ADDENDUM DATE: March 26, 2024

PROJECT: Northwoods Park Middle School Gymnasium & Renovation
904 Sioux Dr.
Jacksonville, NC 28540

Northwoods Park Middle School Gymnasium & Renovations
Project No. 2022035
Pre-Bid Conference Agenda
March 19th, 2024, at 10:00 a.m.

1 A1-02 FLOOR PLAN - GYM ADDITION
1/8" = 1'-0"

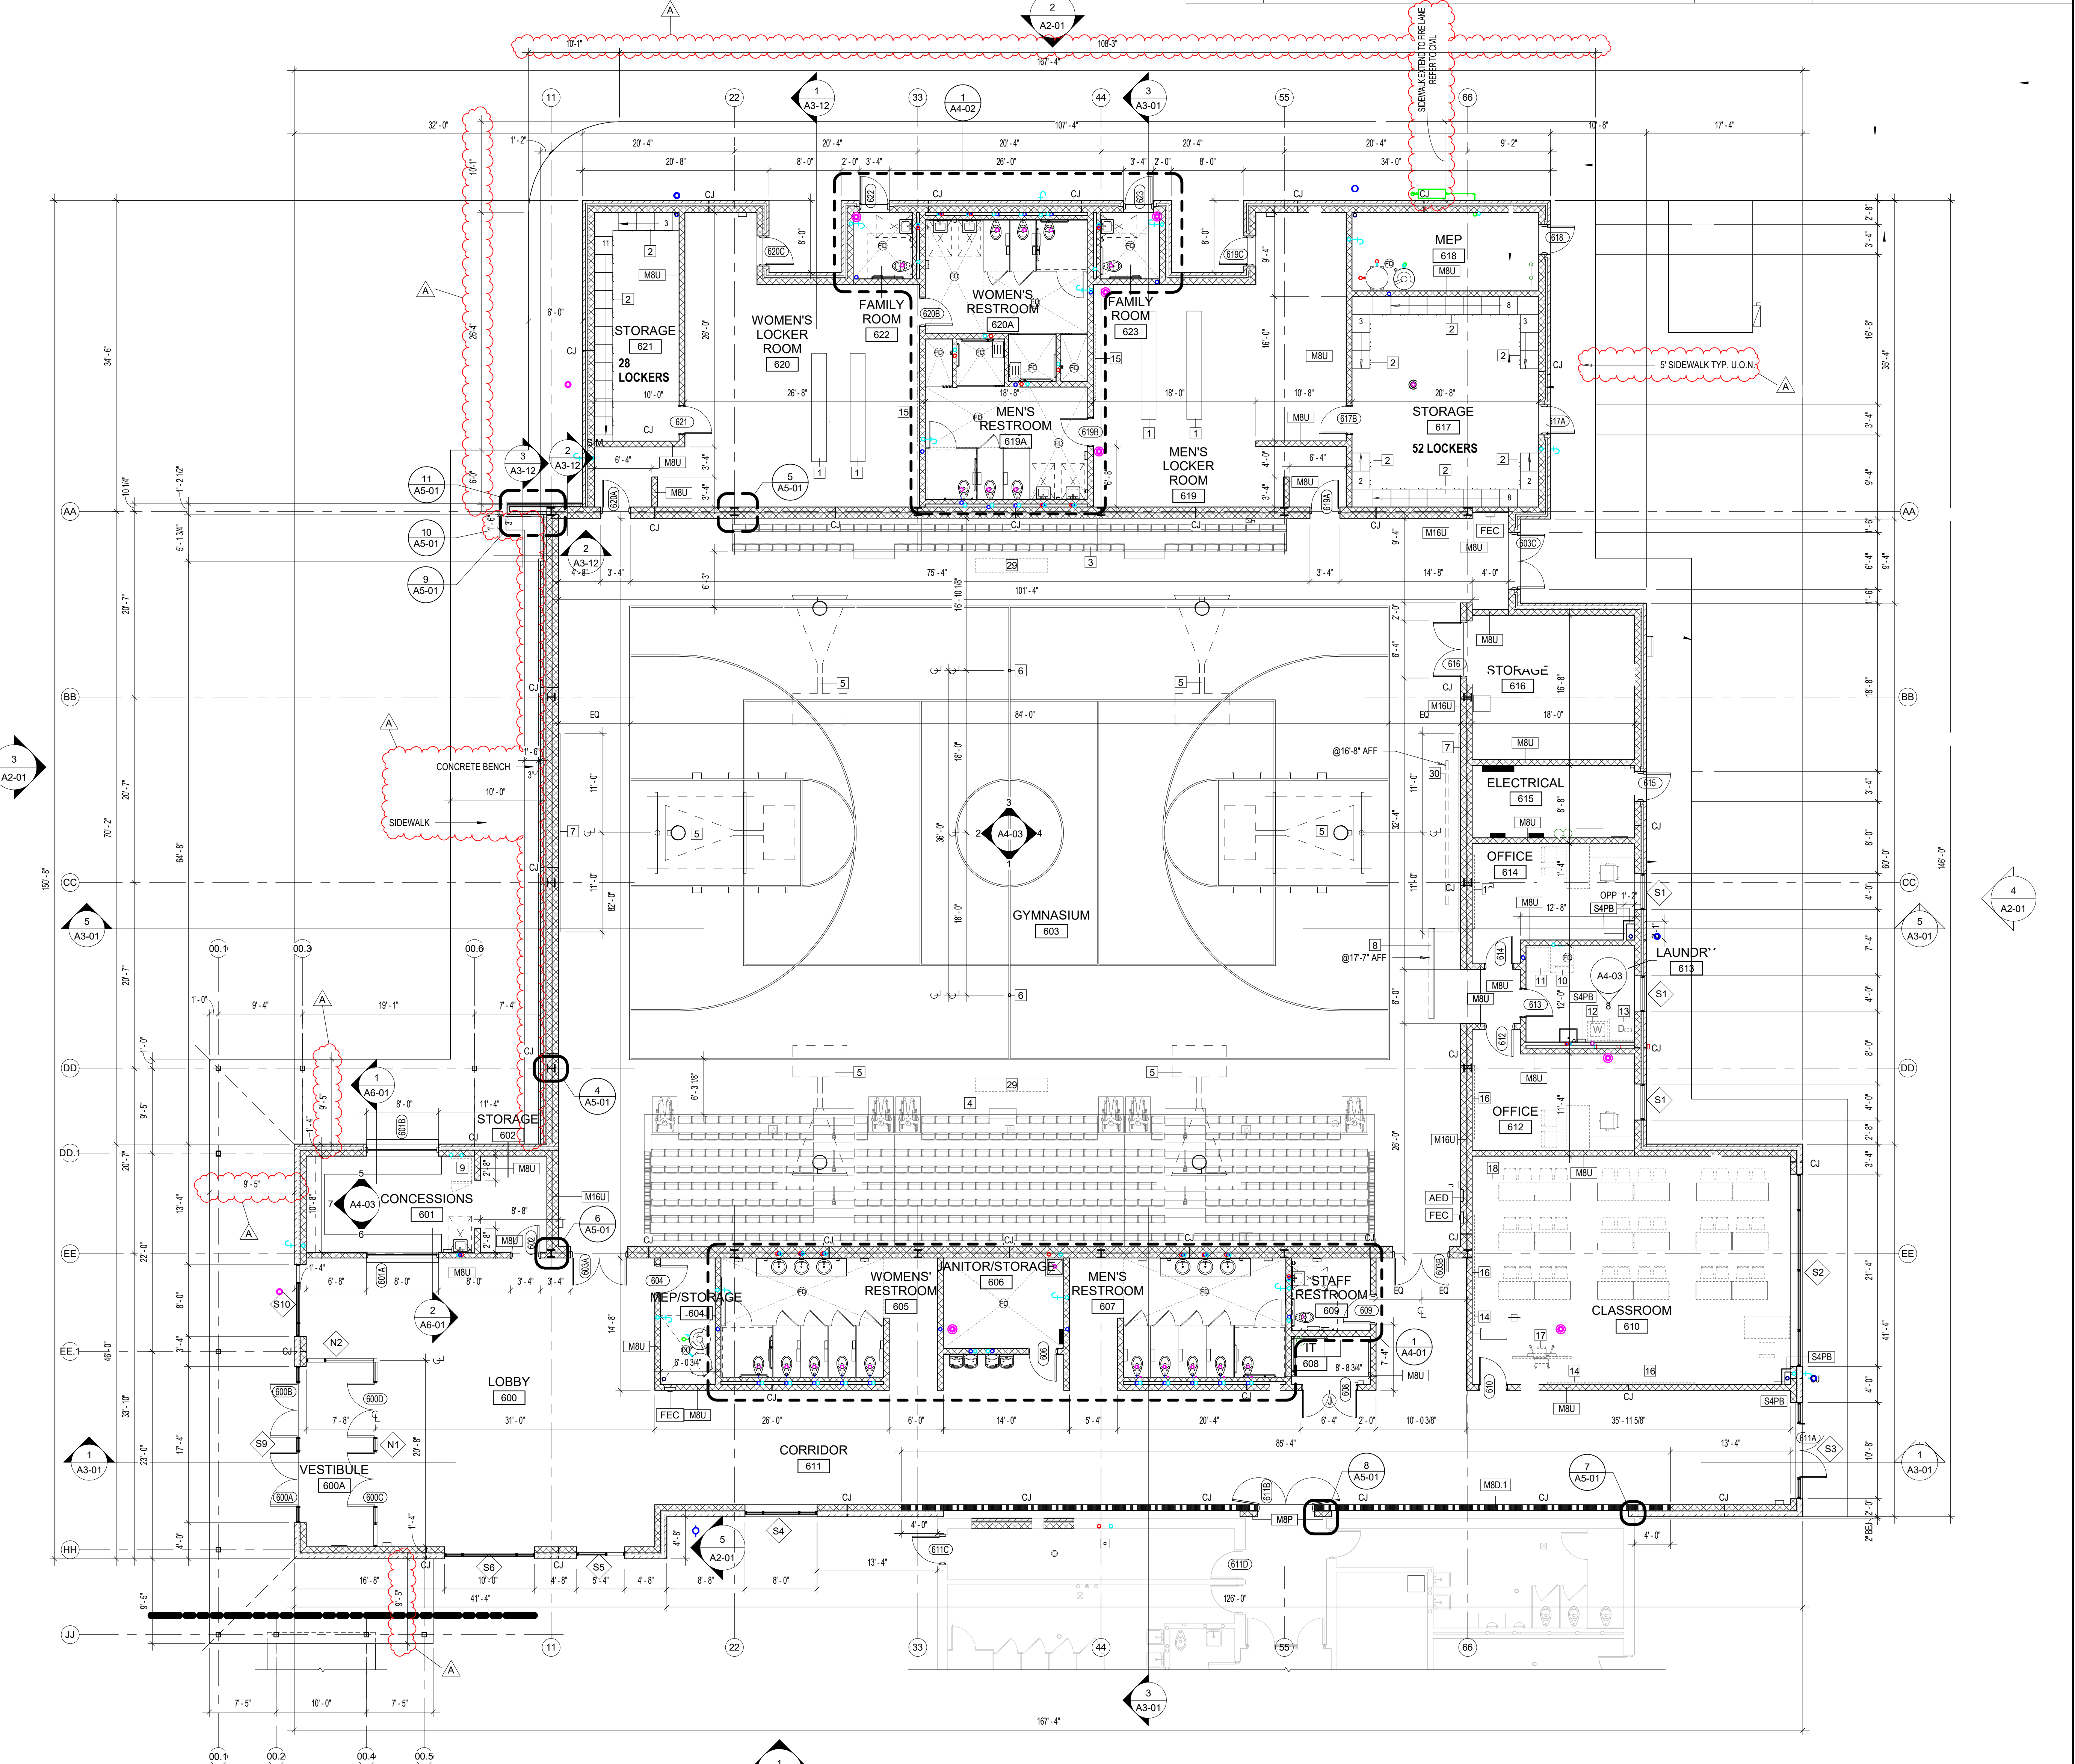
1. **Revision:** Replace sheet A1-02 FLOOR PLAN – GYM ADDITION
Floor plan has been revised to show concrete bench beyond and extents of sidewalk around the gym addition.
